Access Compliance Report Public Rights-of-Way (Curb Ramps)

Main Street: VINEWOOD_LN Cross Street: SLEEPY_HOLLOW_LN Location: SE

ADA ID: RPRK211021134838 Ramp Type: Type 4 - Parallel Initial Pass/Fail: Pass Overall Compliance: No Severity Score: 20

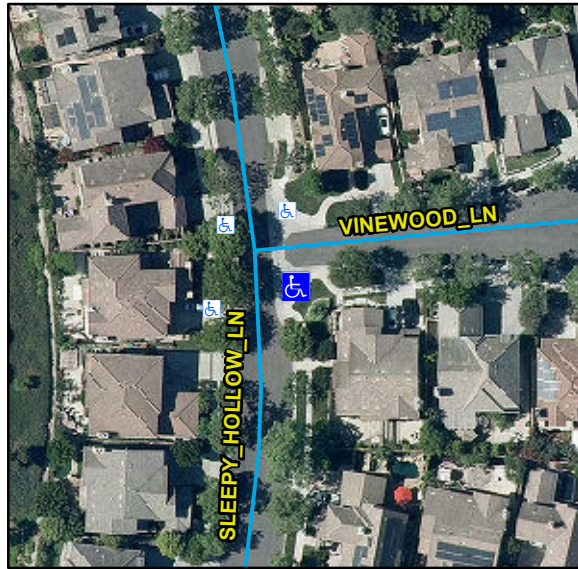
Remove & Replace Curb Ramp With Two New Directional Ramps or Equivalent. Gutter Ponding Observed.
